SOUTHEAST ATLANTA BRANCH LIBRARY

PROJECT: SOUTHEAST ATLANTA BRANCH LIBRARY
LOCATION: 1463 Pryor Road, Atlanta, GA 30315
ARCHITECT: Stanley Love-Stanley.

This Addendum #1 dated September 12, 2014 issued by C D Moody Construction, Co., Inc. is hereby made part of the Southeast Atlanta Library. The changes and/or clarifications included in this Addendum shall be considered as part of the Bidding Documents and shall supersede, amend, add to, or subtract from those conditions included in the original Bid Documents, including the Project Bid Package, Drawings, Specifications, previous Addenda, etc.

This Addendum #2 dated September 25, 2014 issued by C D Moody Construction, Co., Inc. is hereby made part of the Southeast Atlanta Library. The changes and/or clarifications included in this Addendum shall be considered as part of the Bidding Documents and shall supersede, amend, add to, or subtract from those conditions included in the original Bid Documents, including the Project Bid Package, Drawings, Specifications, previous Addenda, etc.

SITE DRAINAGE PLAN

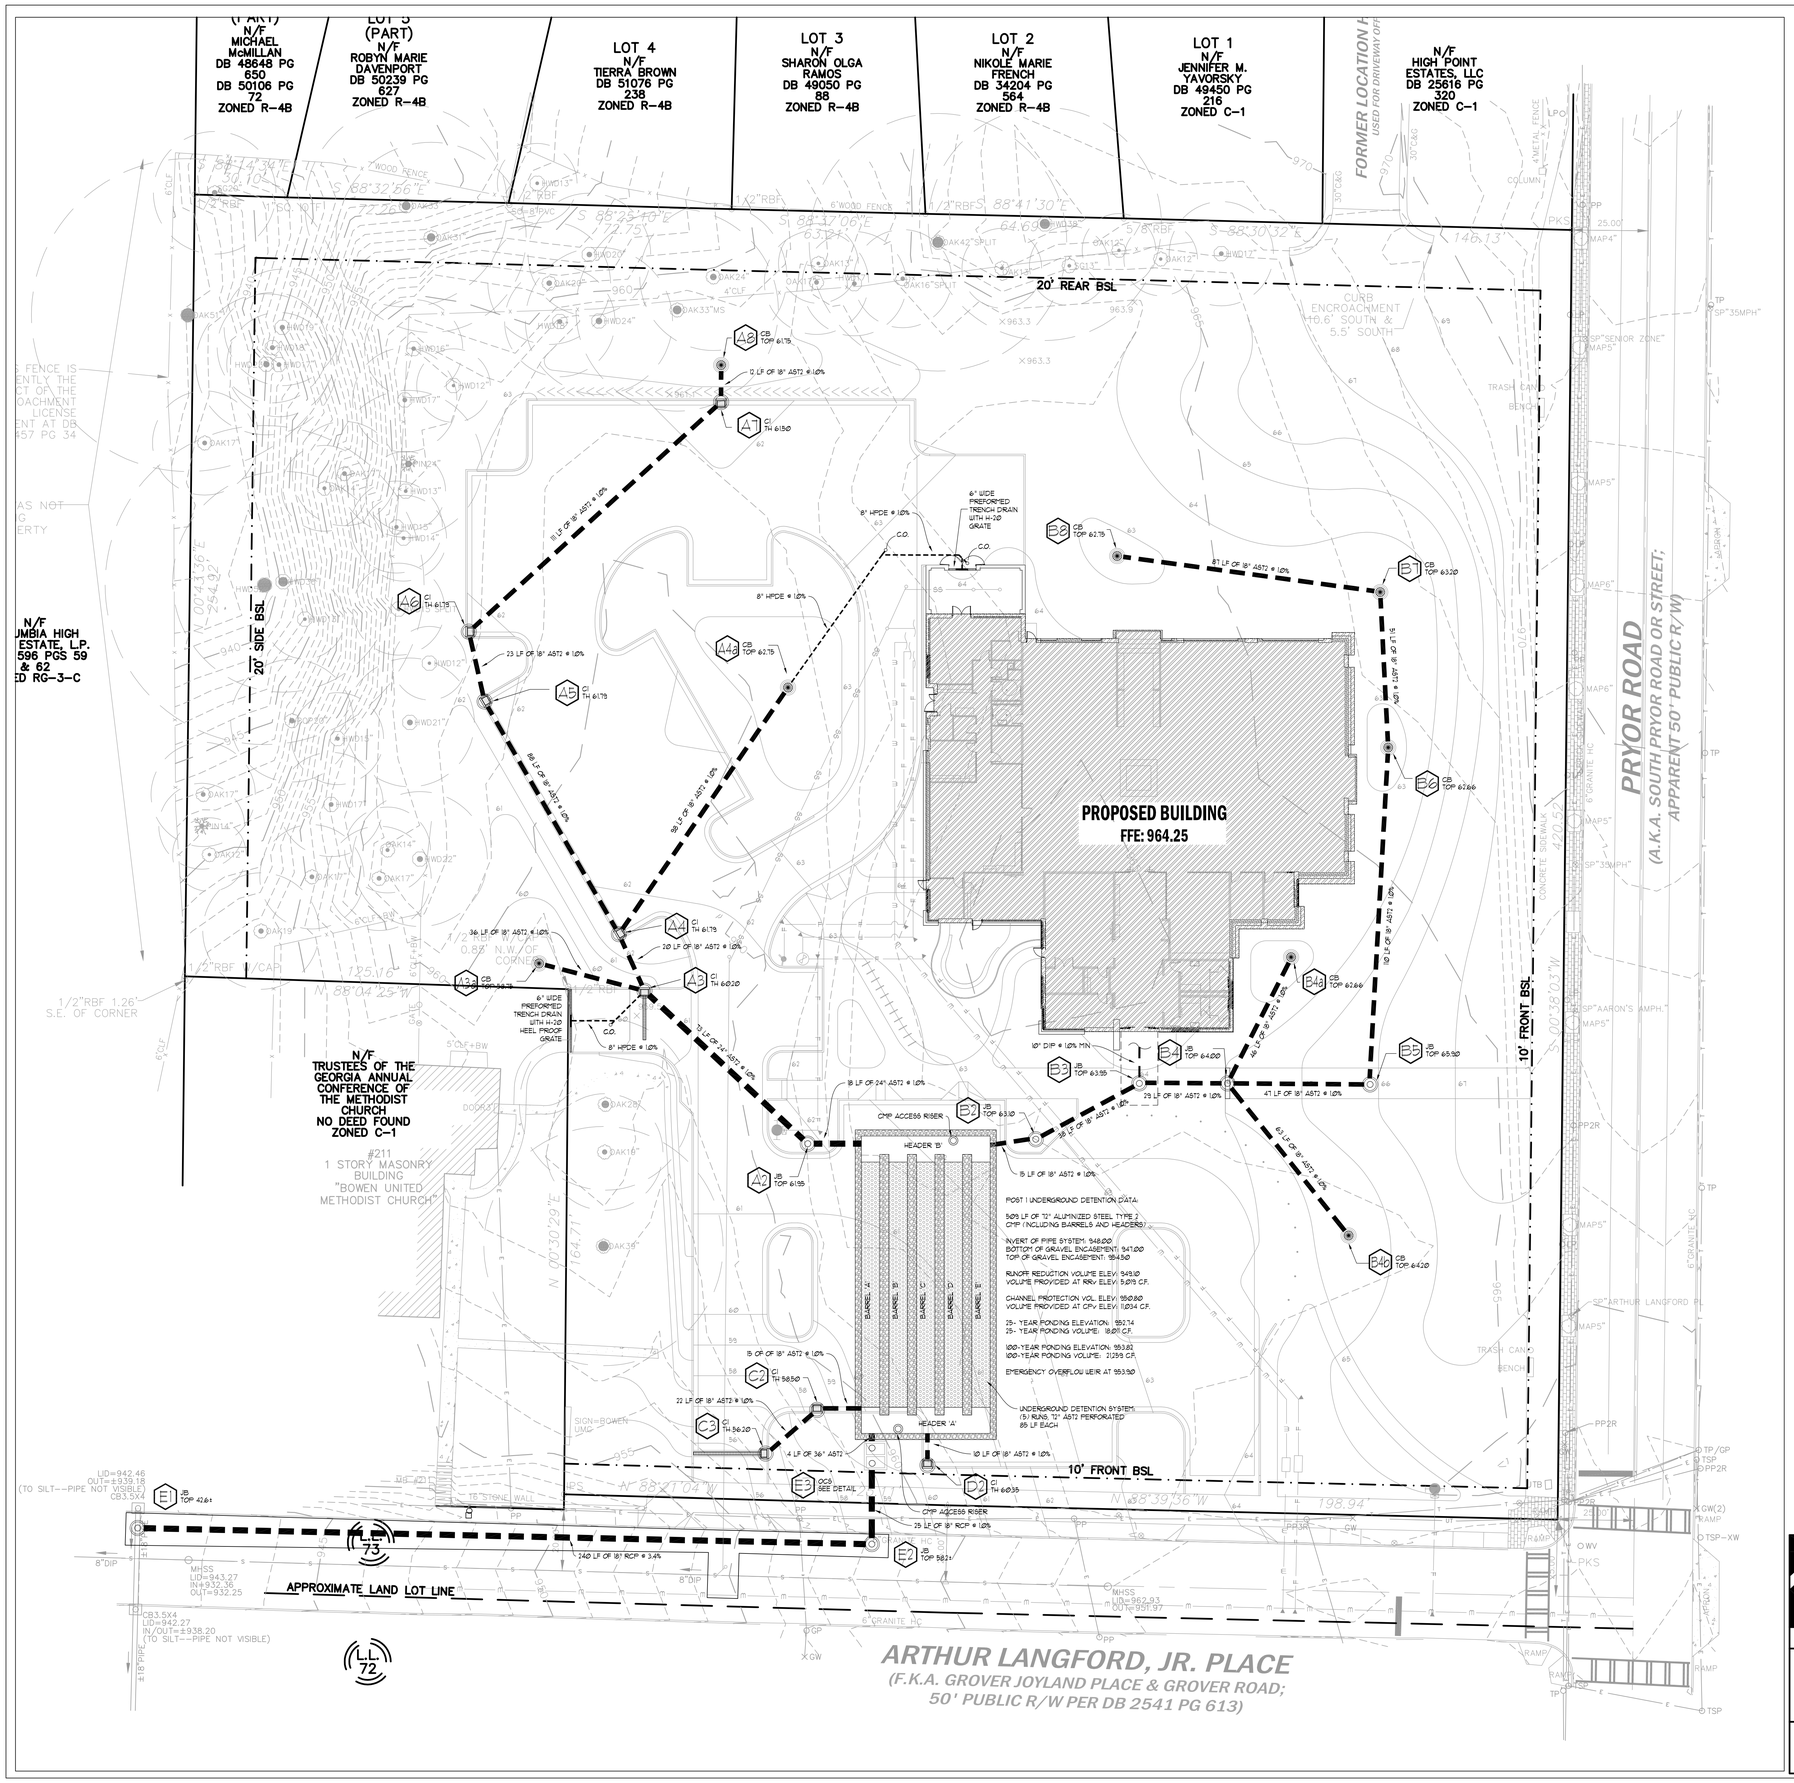
Plumbing Drainage Floor Plan shows locations for downspouts leading from roof drains on the sides of the buildings. Detail 1/C6.10 shows downspout/rainleader cleanout detail but Site Drainage Plan C3.10 does not show locations for piping tie-in to underground storm. Please provide tie-in locations and piping plan.

Response Only one internal drain exits the building, the 10" line to the south. Other roof drains shown on plumbing drawings are overflow from roof that exit via lamb's tongue above grade. Refer to plumbing and architectural drawings for details.

FIRST FLOOR AND FOUNDATION PLAN

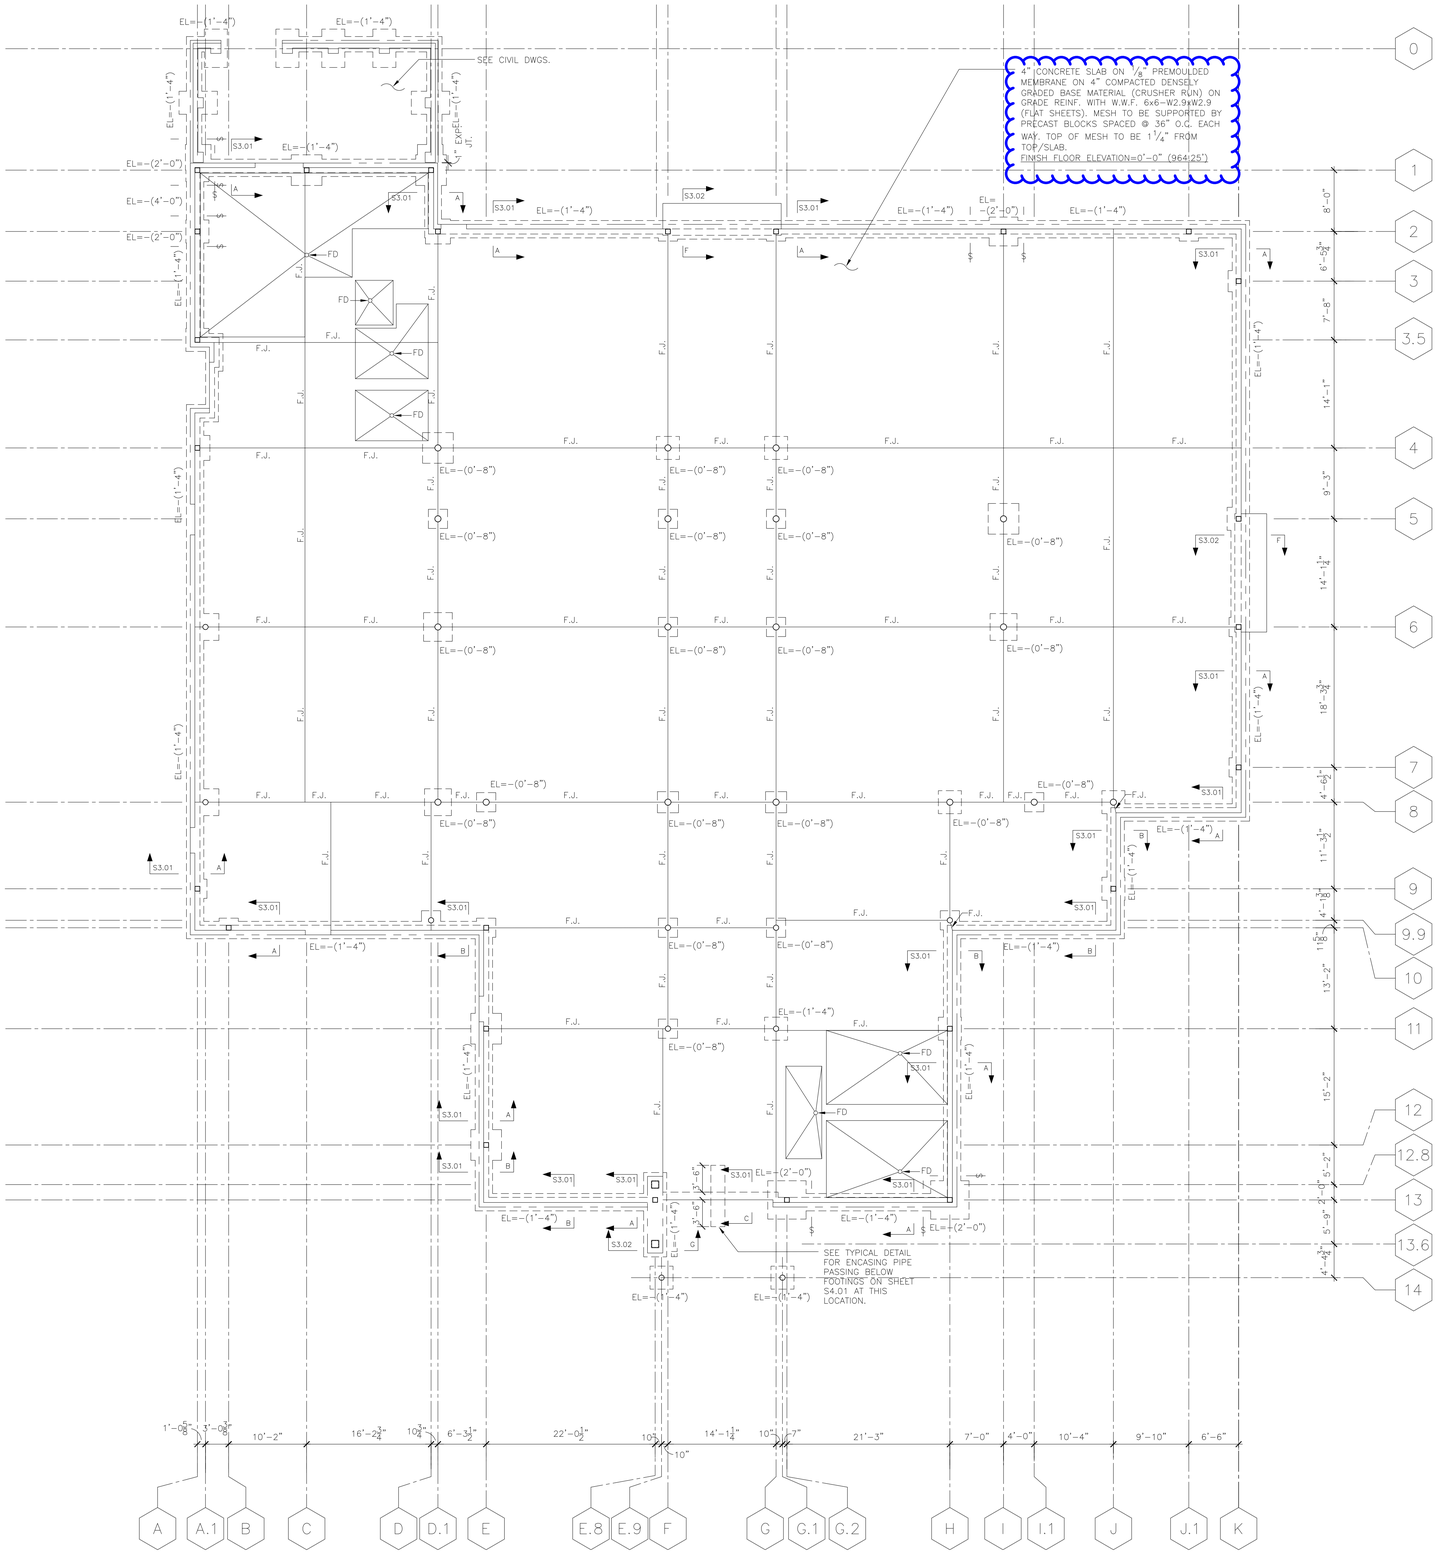
Structural sheet S1.01 notes that base material for slab should be a 4" layer of densely compacted base material (crusher run). The Passive Radon System Detail on M5.01 notes that the base layer directly beneath the slab should be a 4" layer of gas permeable material (clean aggregate or sand). This insinuates that the materials should not be fully compacted to allow for permeability. CDM has a concern that if base layer of material directly beneath the slab is not densely compacted as the Structural Drawings require, there will be Structural issues with the support of the concrete slab above resulting in cracking and possible structural failure of the slab. Please advise. See attached referenced documents.

DRAWN	KAM, GSM
CHECKED	AAW
DATE	07-14-2014
SCALE	AS NOTED
PROJECT NO.	4110
FILENAME	
DRAWING NO.	C2.00

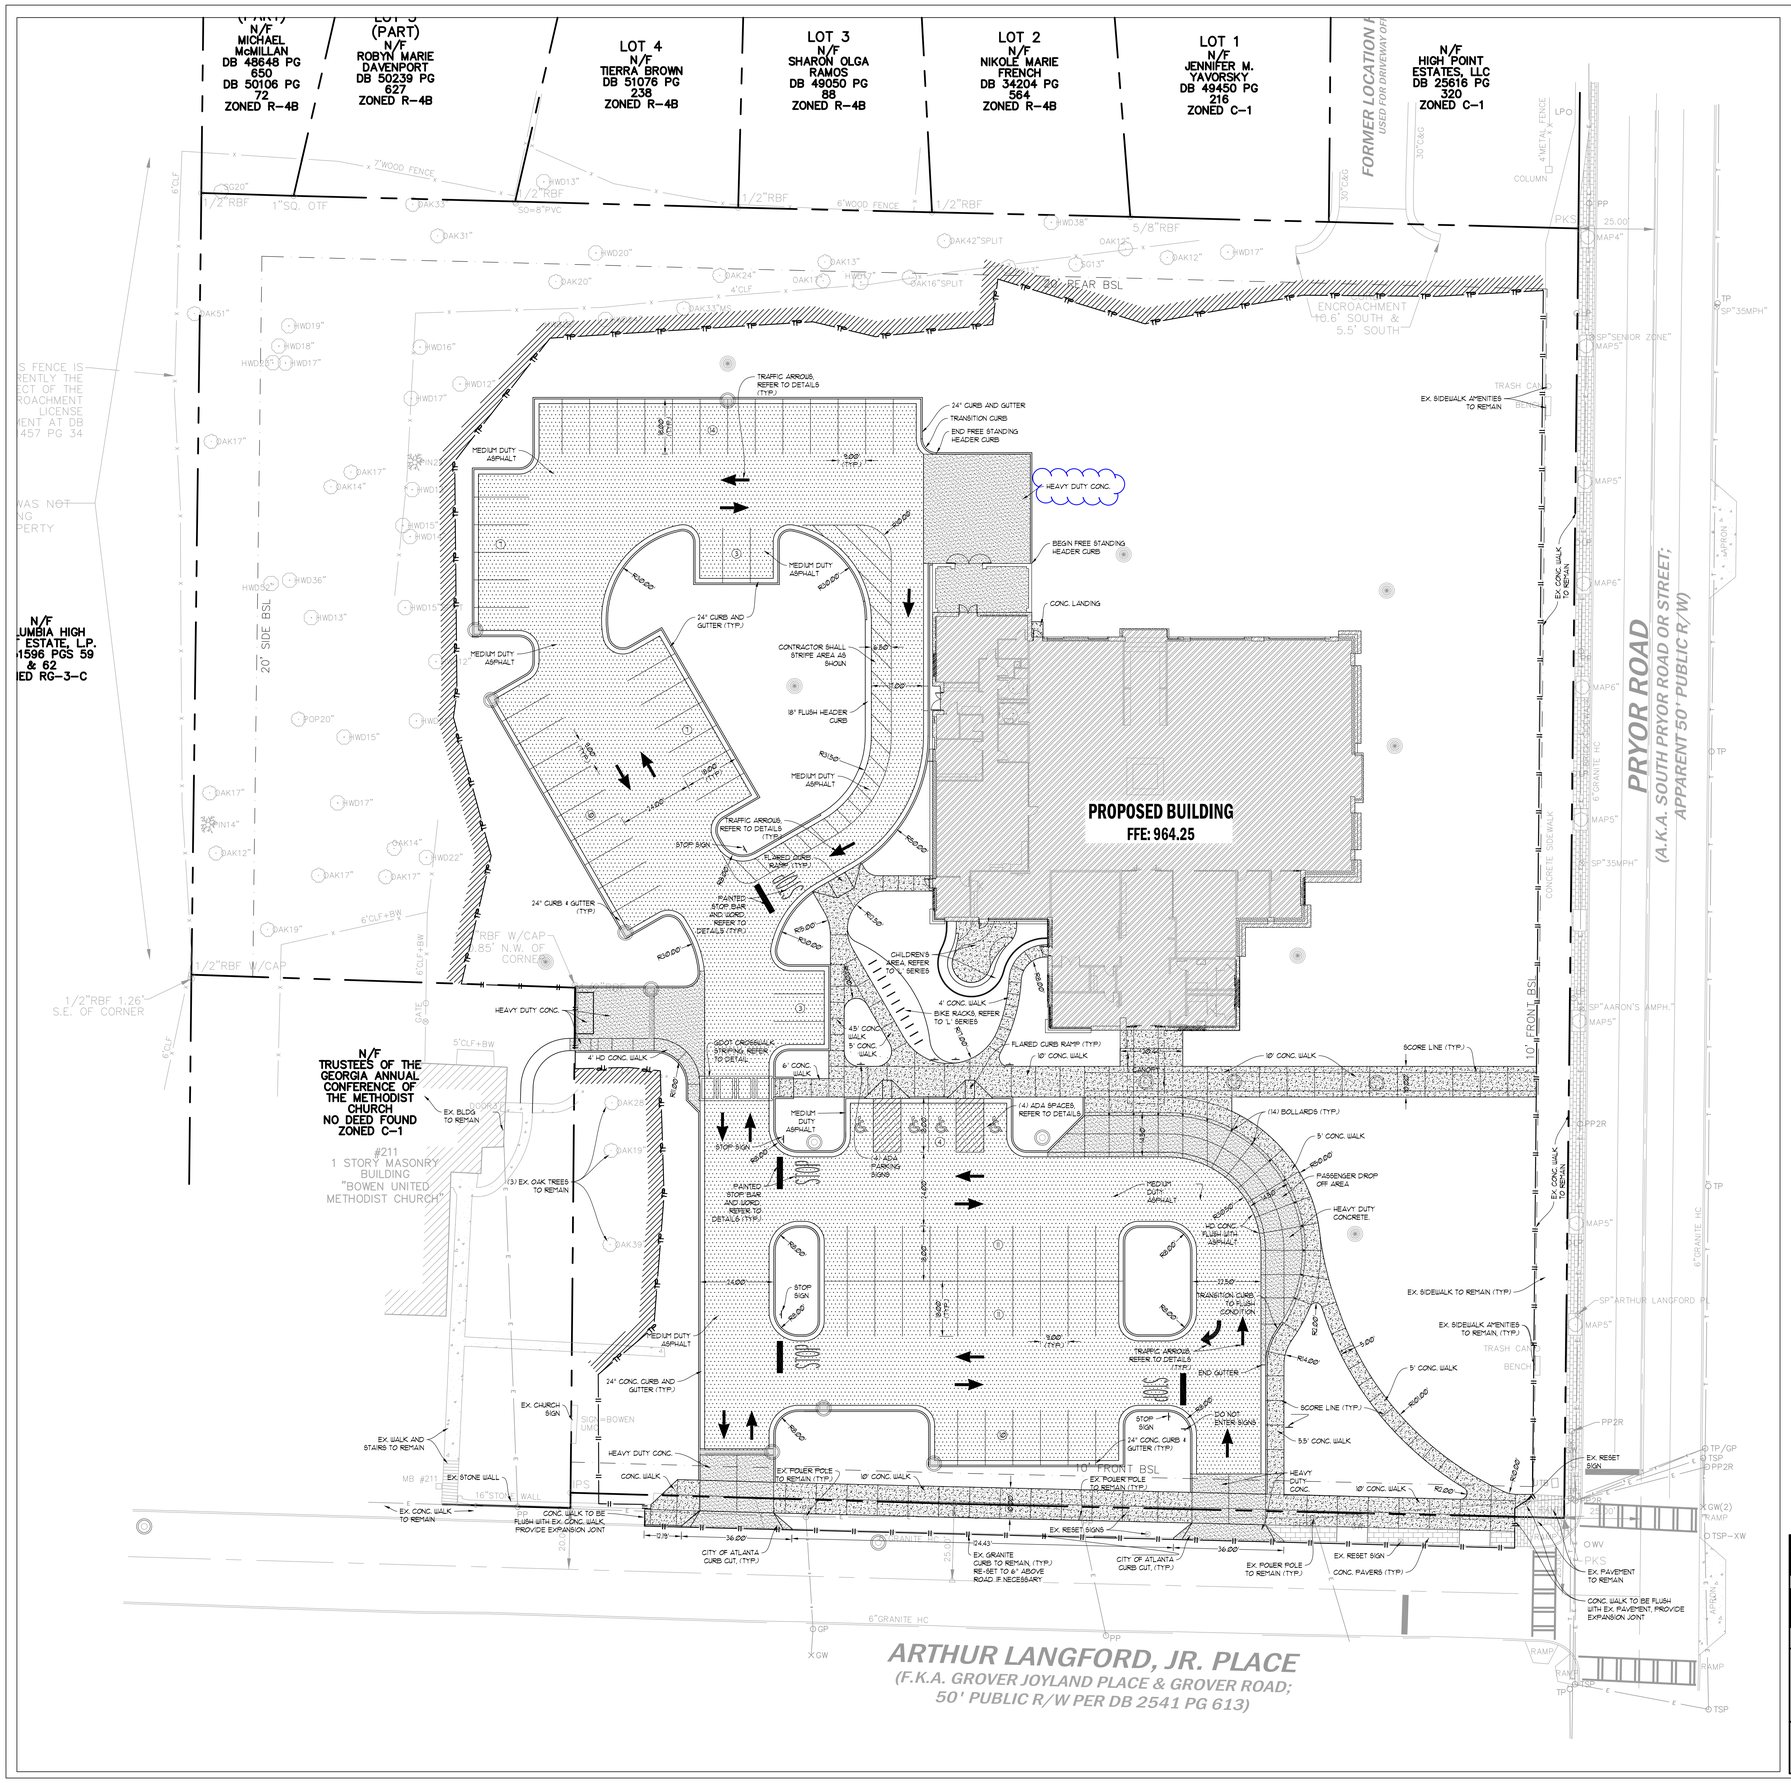
Sheet C2.00 notes that slab for mechnacal yard should be heavy duty pavement (Ref. Detail 3/C6.00). Finish schedule on A1.22 states that the mechanical yard should be gravel. Please confirm mechanical yard will recieve heavy duty pavement.

1 A1.30 FURNITURE PLAN

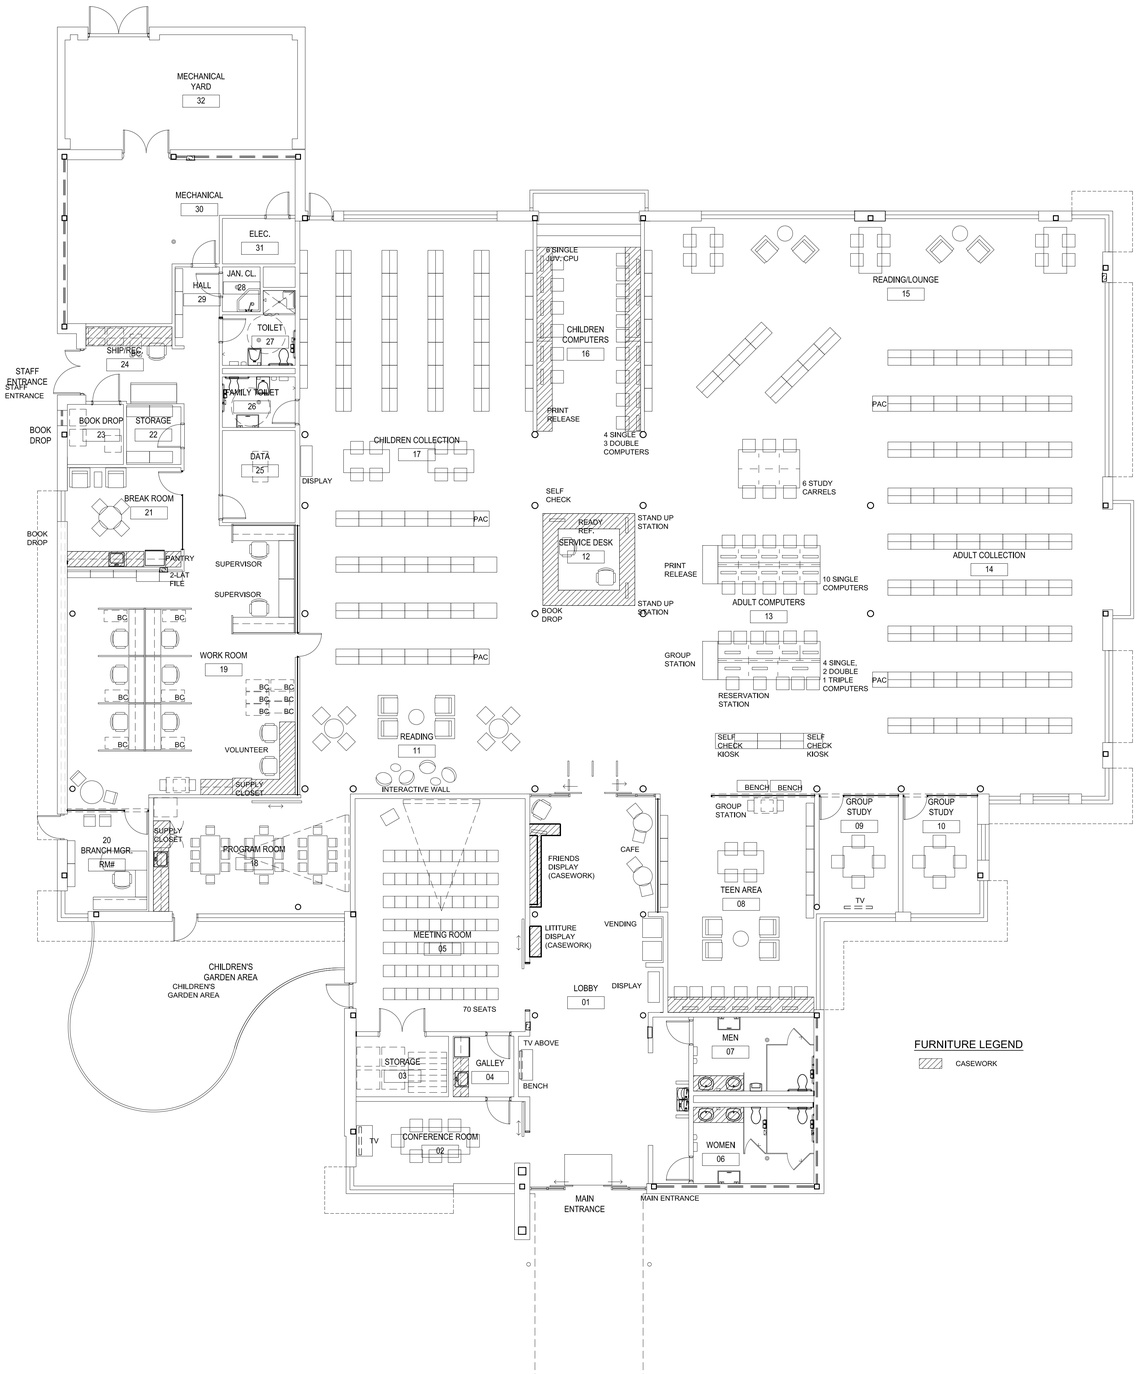
Please revise Furnature Plan A1.31 to show what assembies are included in the Architectural Woodwork and Solid Surface Countertop specifications.

See attachment with A1.31 revised
September 26, 2014
